South Texas Project
Units 1 and 2
Docket Nos. STN 50-498 and STN 50-499
Additional Information Regarding Sensitivity Studies for
STPNOC Risk-Informed Pilot GSI-191 Application
(TAC NOS. MF2400 – MF2409)

**Additional Information Regarding Sensitivity Studies for
STPNOC Risk-Informed Pilot GSI-191 Application**

SNPB-3-20 Supplemental Information

Figure 1. PCT (Reference Case B1; Sensitivity Case B1F)

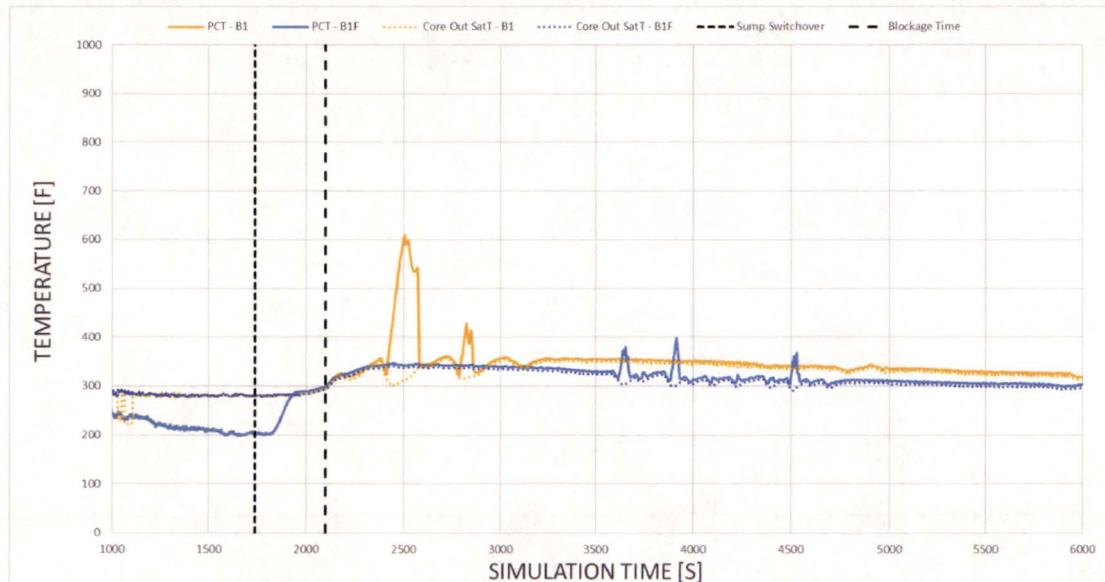
The staff understood that the bypass sensitivity study would assume a true single worst failure. The staff does not believe the single failure of the ECCS train is the worst failure. Also, the staff believes a top-peaked power shape is necessary and appropriate for this analysis. STP's use of Appendix K decay heat, steam generator tube plugging, and RWST size and temperatures, and sump temperature assumptions appear appropriate.

An additional sensitivity analysis is conducted to investigate the effect of the power shape on the PCT under the condition of core barrel/baffle bypass open during the post-core blockage LTCC. The sensitivity is executed under the same assumptions and conditions applied to the sensitivity B1 described in the answer to SNPB-3-20. The input file is generated from the one used to perform the simulation B1, only changing the core BB bypass (junction 84501) to be open during the post-core blockage LTCC. As describes in the answer to RAI-SNPB-3-3, this configuration is likely to be the most realistic condition.

No appreciable differences in PCT during the post-core blockage LTCC are found, as shown in Figure 1. Saturation temperature is also included in the figure.

The PCT of the sensitivity case appears smoother than the one simulated under the reference conditions (core bypass blocked).
